For Official Use Only 請勿填寫此欄	Application No. 申請編號	A/YC-PH/1077
	Date Received 收到日期	2025-07-08

1. This Planning Statement is submitted to the Town Planning Board (“the Board”) on behalf of Mr. YIK King Kung Philip (“the Applicant”) in support of the planning application for ‘Proposed Temporary Warehouse (excluding Dangerous Goods Godown) with Ancillary Office and associated Filling of Land for a Period of 3 Years’ (“the Proposed Development”) on Lots 29 (Part), 33 (Part) and 35 (Part) in D.D. 111 and Adjoining Government Land, Pat Heung, Yuen Long (“the Site”) under Section 16 of the Town Planning Ordinance.

We would like to submit a response-to-comment, drainage proposal (Plans 6.1 and 6.2) and hydraulic calculations to respond to the comments from Transport Department, Drainage Services Department and Lands Department.

Map A

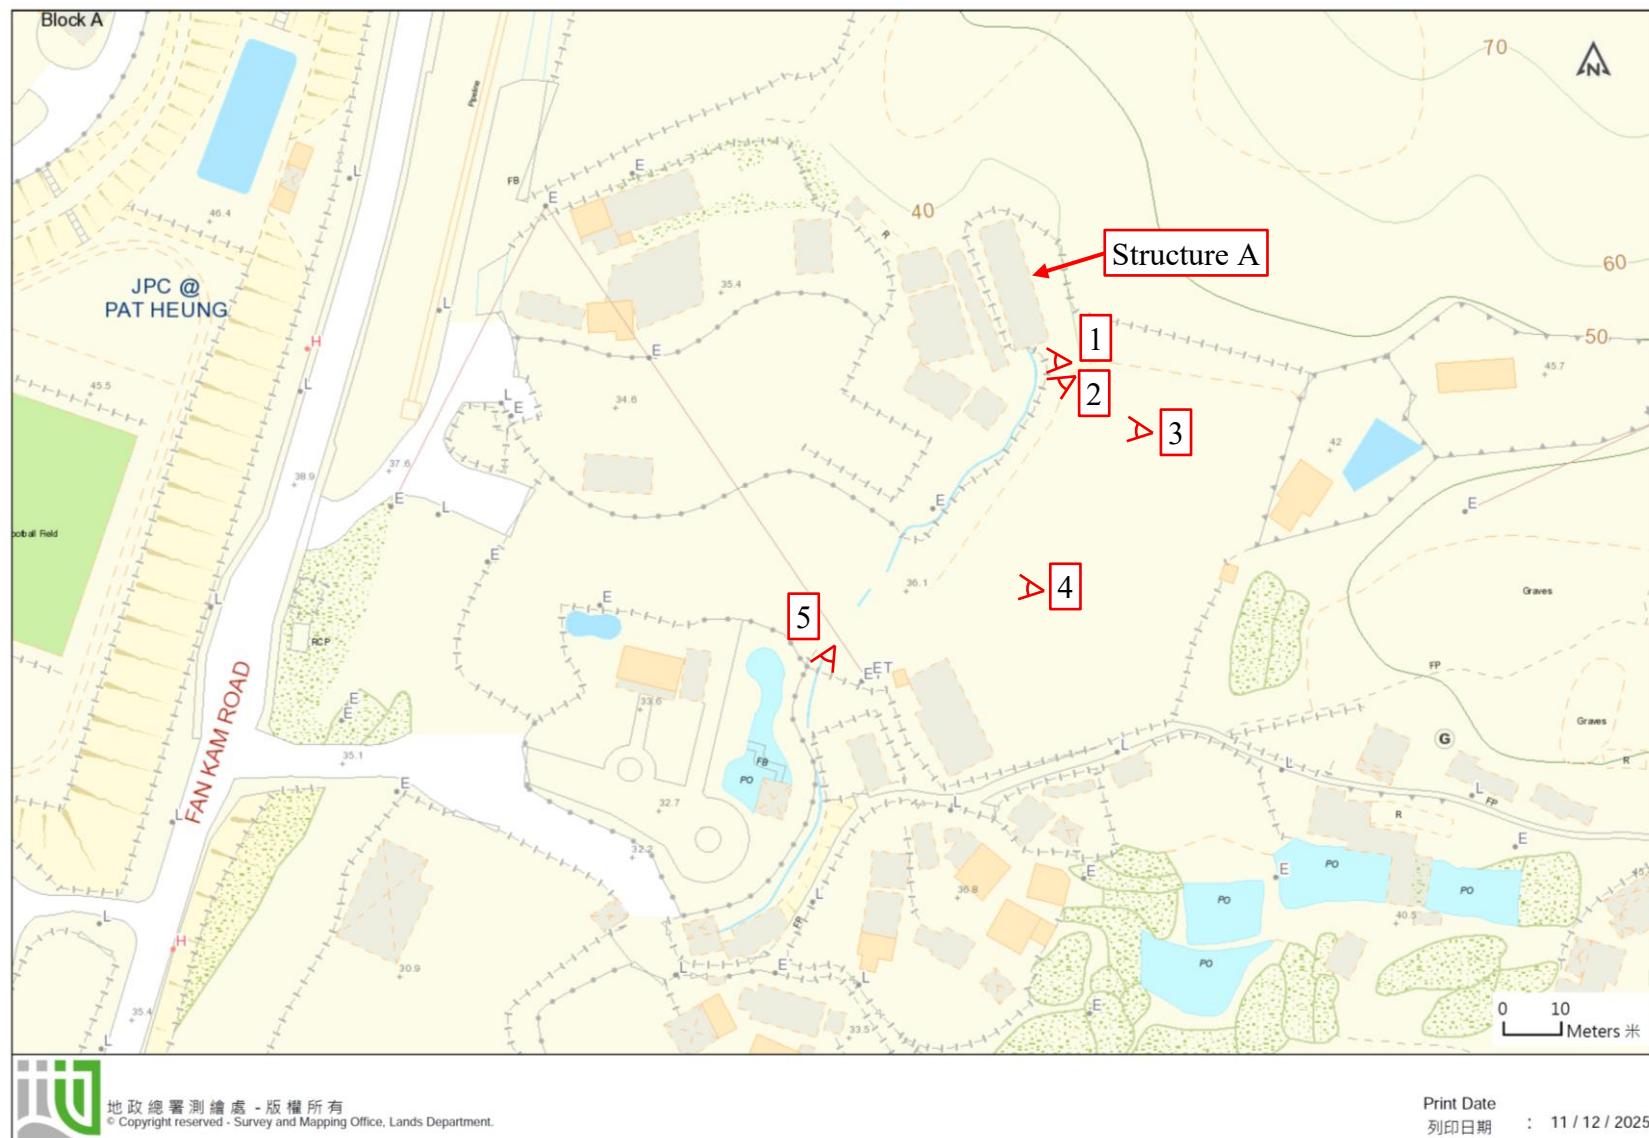
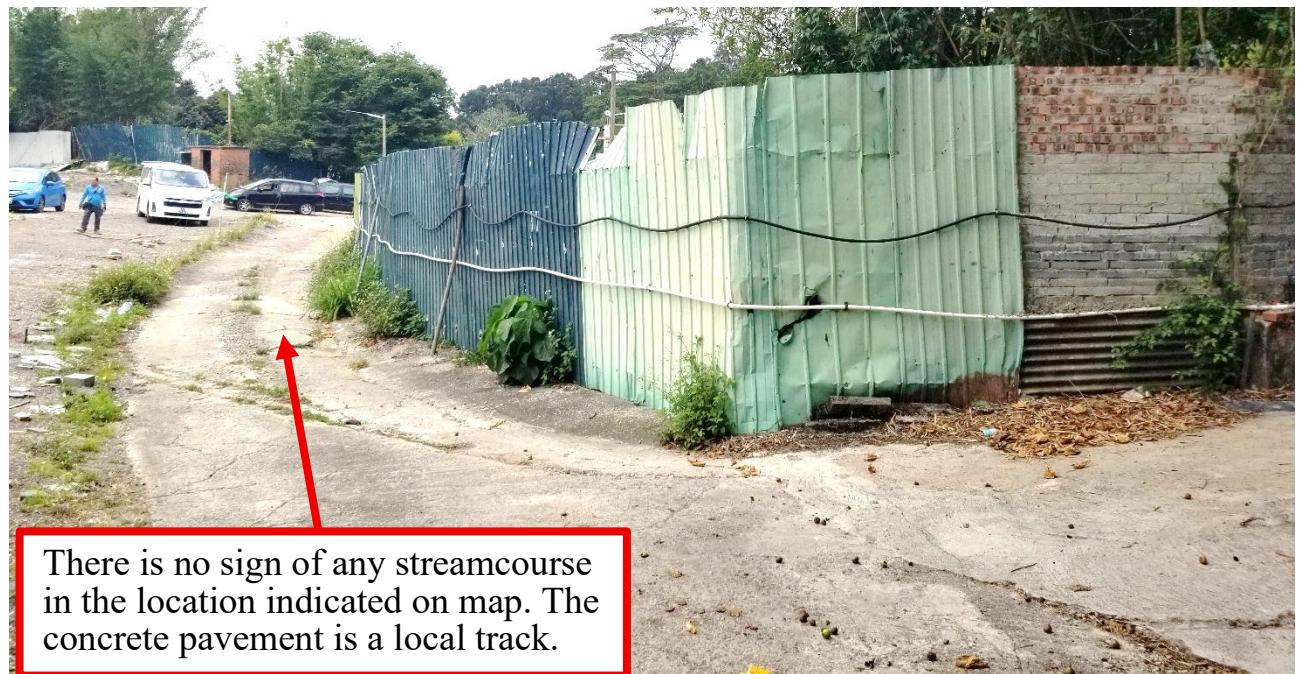
2 (b)	<p>According to the RtC 2, the existing streamcourse/channel on government land within the application site will be preserved and maintained. Please elaborate the details, in particular, the crossing details above the existing streamcourse/channel should be included in the submission for our comment and consideration. Please note that proposal for concealing of the existing streamcourse/channel will not be considered.</p>	<p>Please refer to comment 2(a) above.</p> <p>We would like to clarify that the applicant has not concealed any existing streamcourse/channel on government land. No existing streamcourse/channel is observed on government land within the site.</p>

1:500	Drainage Proposal Lot 29(part), 33(part) and 35(part) in DD.111 and adjoining government land Yuen Long, N.T.	Goldrich Planners & Surveyors Ltd.
December 2025		Plan 6.1a (P 25025)

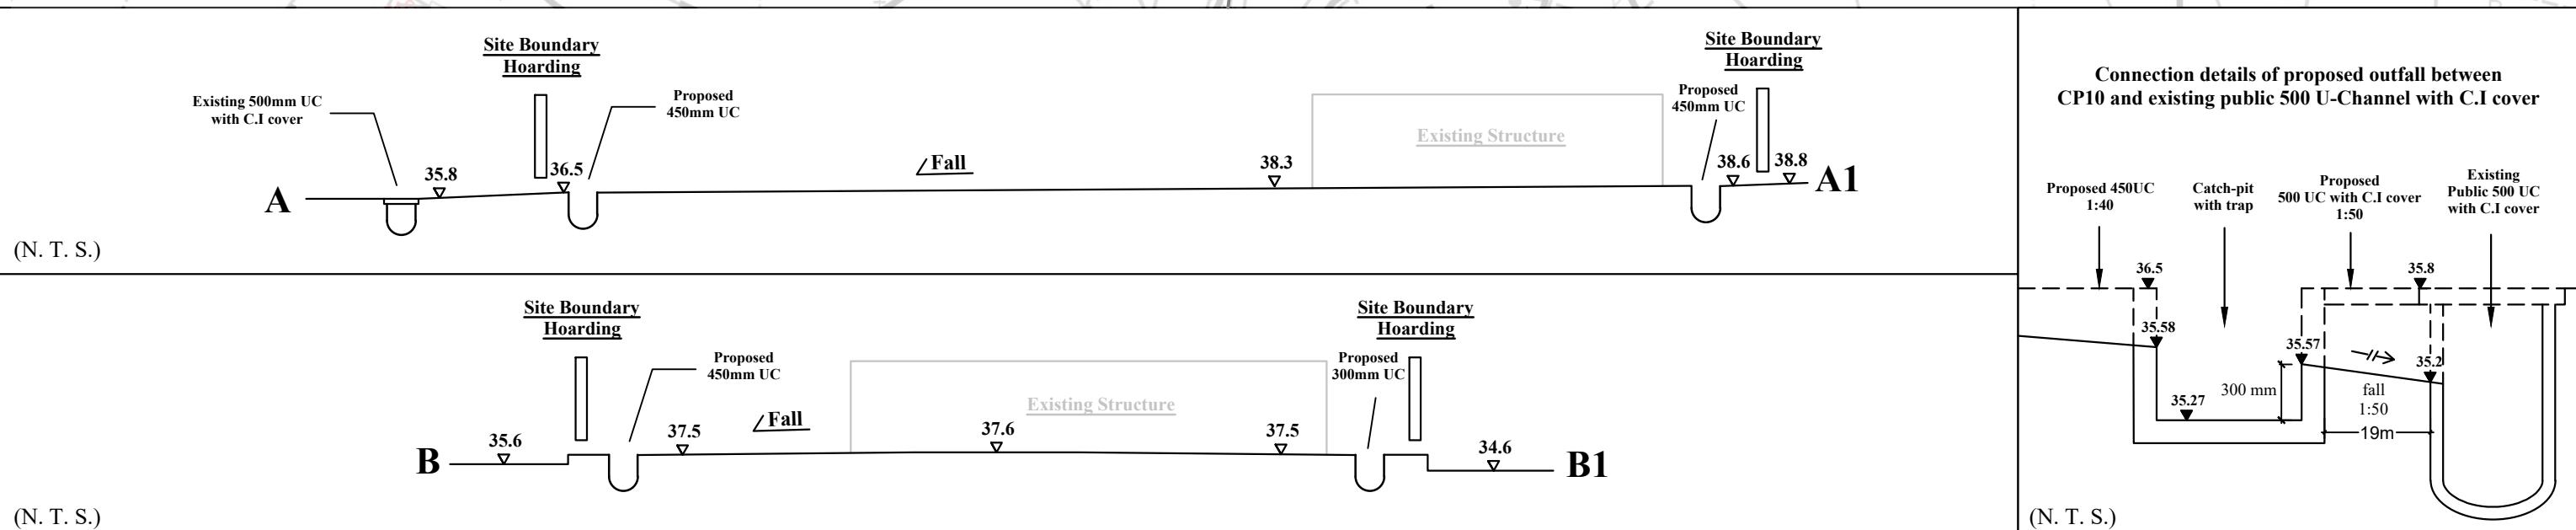
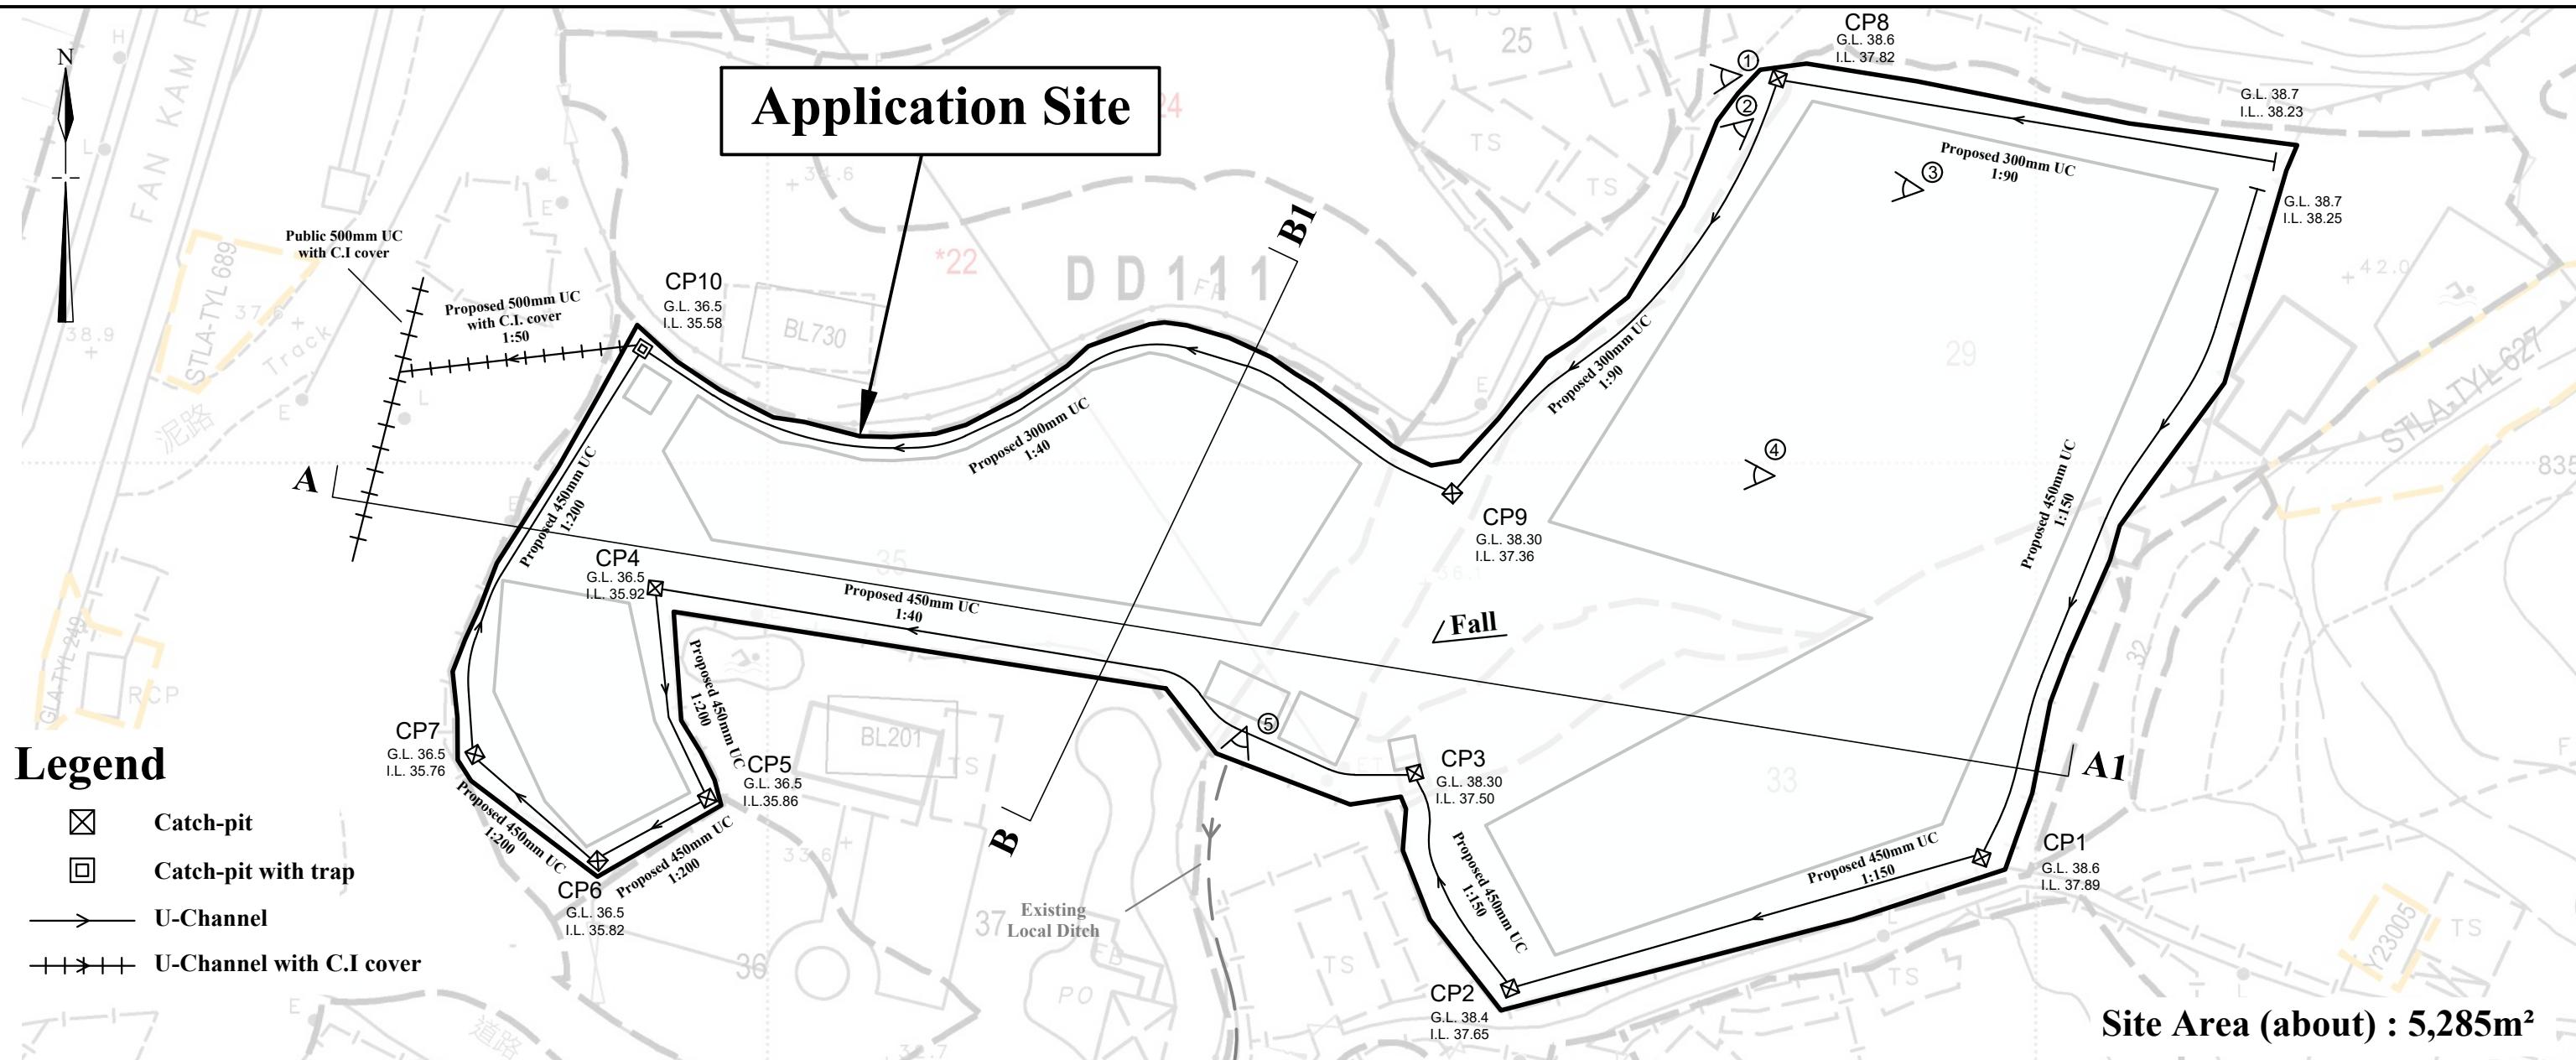
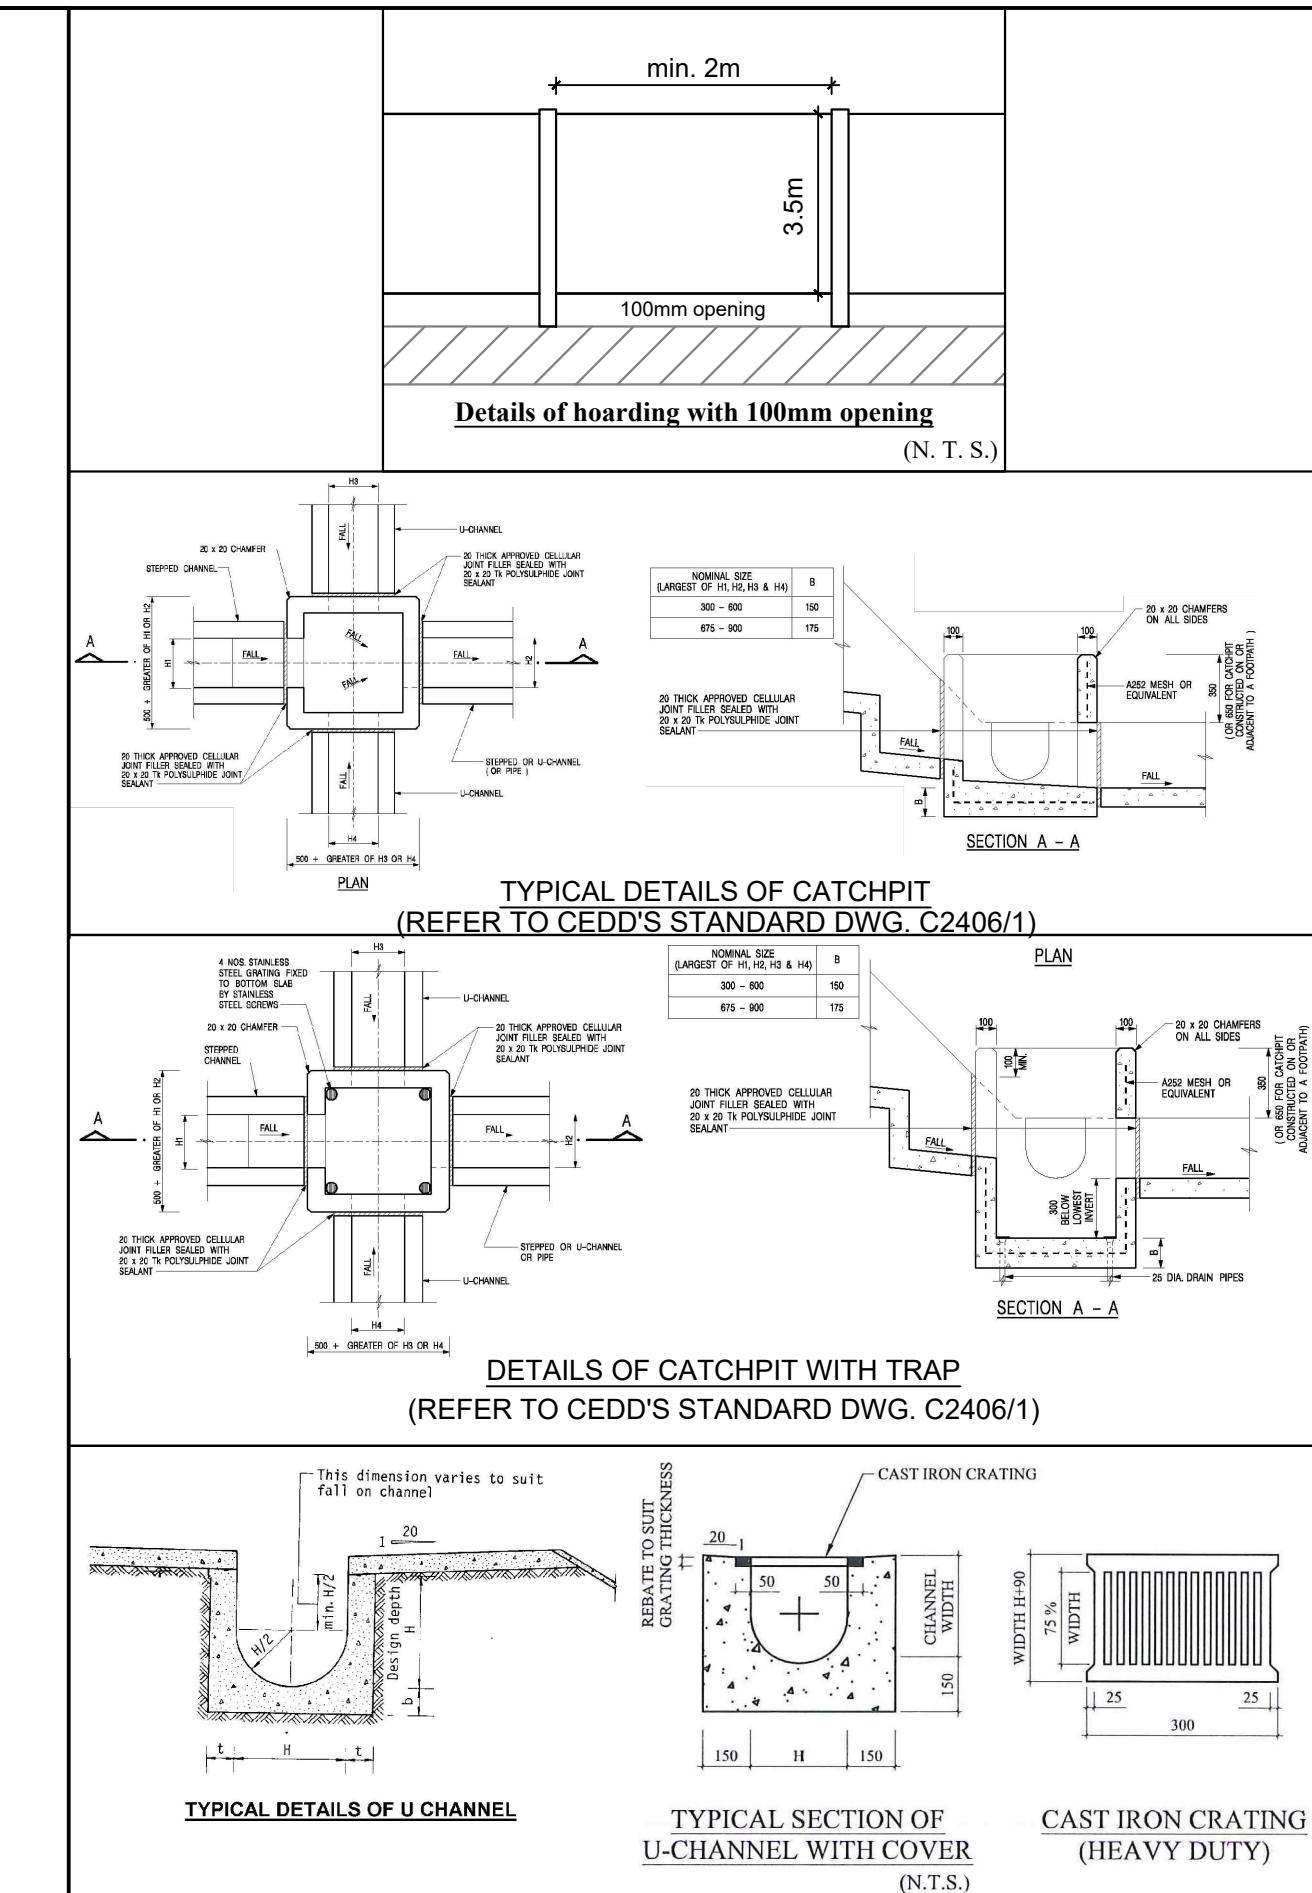
Comments	Responses
2 (a)	<p>The application site is in the vicinity of an existing streamcourse. The applicant shall be required to place all the proposed works 3m away from the top of the bank of the streamcourse. Please show the details in the layout plan. All the proposed works in the vicinity of the streamcourse should not create any adverse drainage impacts, both during and after construction. Proposed flooding mitigation measures if necessary shall be provided at the resources of the applicant to my satisfaction.</p>	<p>We have visited the site. We have not observed the “existing streamcourse” indicated in the plan provided by you. Please refer to photographs showing viewpoints 1.</p> <p>The piece of government land is a local track to structure A and other houses in the north-east of the site.</p> <p>We have not observed any streamcourse in the middle of the piece of land. Please refer to photographs showing viewpoints 2-4.</p> <p>However, to the south side of the site at viewpoint 5, we observe a local ditch about 2m wide.</p> <p>We confirm that all the proposed works will be placed 3m away from the top of the bank of the existing local ditch outside the site at the south.</p> <p>All the proposed works in the vicinity of the existing local ditch would not create any adverse drainage impacts, both during and after construction.</p> <p>Proposed flooding mitigation measures, if necessary, will be provided at the resources of the applicant.</p>

Comments	Responses
2 (c)	Please make reference to paragraph 6 of DSD Technical Note No.1 for sizing of the drainage channel.	The calculations are worked according to DSD Stormwater Drainage Manual. The sizing of the drainage channels is adequate to collect the surface runoff from the catchment area.
2 (d)	Length of u-channel L_c of 78.3m is adopted for calculating the u-channel size for Area A ($3,389 \text{ m}^2$). Please revise the calculation by dividing the u-channel length in two sections, with section one at the northern side and the section two at the North-western for calculation of the u-channel size for Area A.	Please refer to updated hydraulic calculations. The calculation of the u-channel size for Area A is divided into two sections.
2 (e)	Please refer to (d) above to revise the calculation of u-channel size for Area C ($6,778 \text{ m}^2$).	Please refer to updated hydraulic calculations. The calculation of the u-channel size for Area C is divided into two sections.
